**EAGLE MOUNTAIN CITY**  
City Council Staff Report

**APRIL 7, 2015**

*Project:* **SilverLake 14 & 15 – (1) Preliminary Plat; (2) Site Plan**  
*Applicant:* Nate Hutchinson – Flagship Homes  
*Type of Action:* Action Items  
*Planning Commission:* Recommended Conditional Approval (3-1) on March 10, 2015

**STANDARD 6-PLEX FRONT ELEVATION** (for elevations not fronting a public street)  
*Colors may vary from building to building*

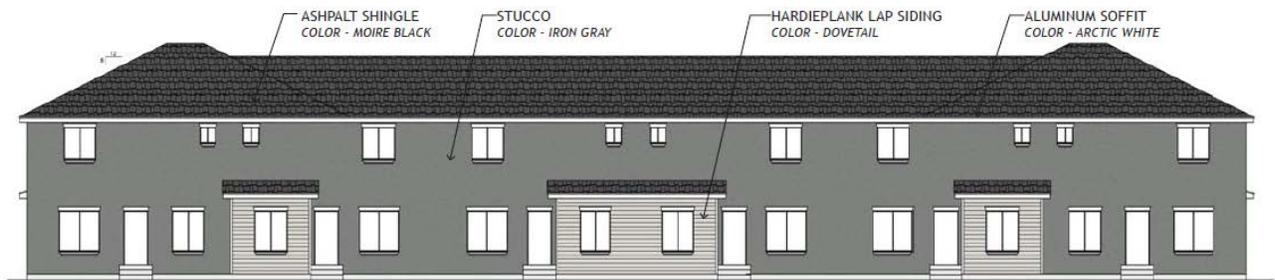
We (Staff) recommend that you (City Council) not approve the proposed changes to the building elevations (discussed later in this report), and that you consider improvements to the building elevations, especially the rear and side elevations. You may consider a traffic study as well. Also, we recommend that you add a condition of approval requiring the entryway monument sign at Woodhaven Boulevard and Pony Express Parkway be constructed prior to August 31, 2015. A plan/design for this monument should be approved by the City prior to construction.

**Revised Proposed Townhome Elevation – Front**  
**Removing stone/rock**

**STANDARD 6-PLEX REAR ELEVATION** (for elevations not fronting a public street)  
*Colors may vary from building to building*

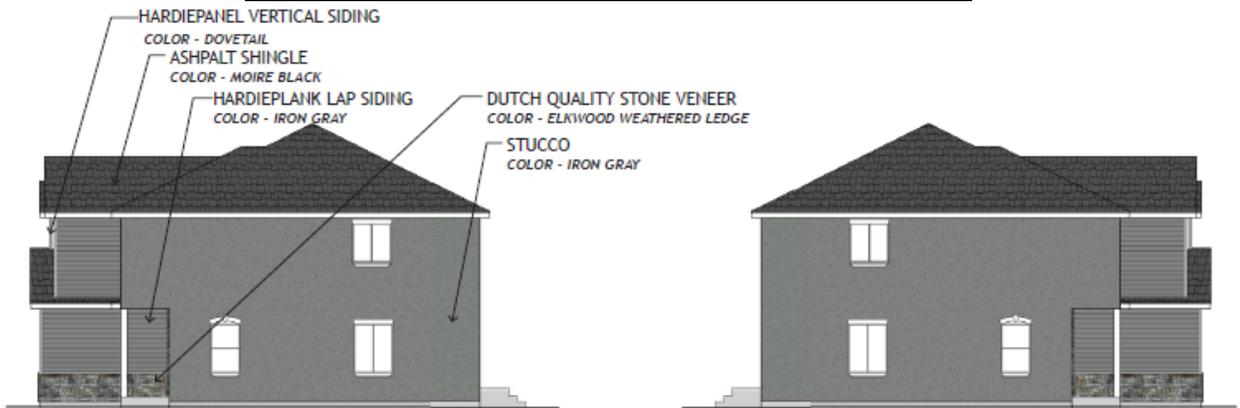
**Proposed Townhome Elevation – Rear**  
**Recommended for Approval by the Planning Commission**

**Proposed Townhome Elevation – Sides**  
**Recommended for Approval by the Planning Commission**

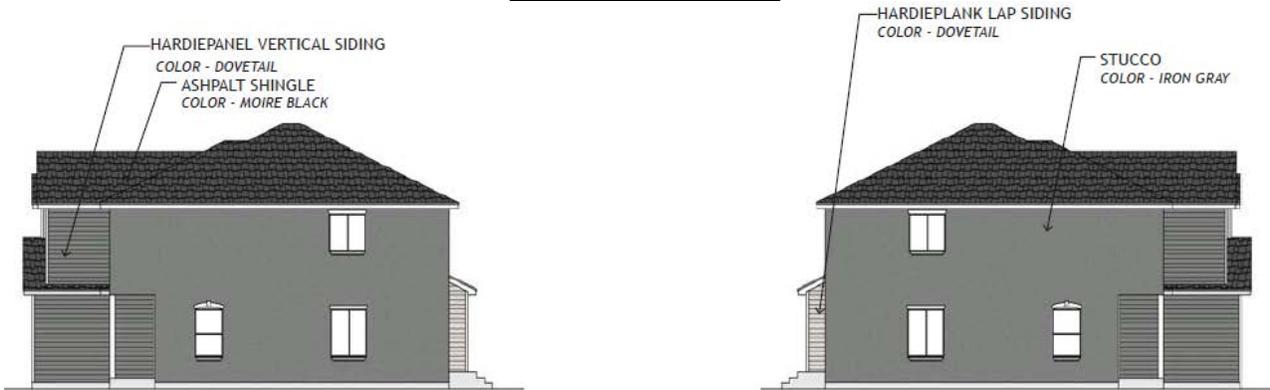
- 1. Stucco shall not exceed 25% of any front elevation and elevation facing a public street.**
- 2. Developer shall improve the side elevations with more architectural variations.**
- 3. The clubhouse shall be a minimum of 1,200 sq ft & \$1,000 per unit cost.**
- 4. The clubhouse elevations must be reviewed for approval by City Council & be consistent in style and color with the townhomes or homes.**
- 5. All lighting must comply with the City's "dark sky" lighting standards in EMMC Chapter 17.56.**
- 6. The plans must be reviewed by the Fire Marshal for approval.**

**Revised Proposed Townhome Elevation – Sides  
Removing rock/stone**
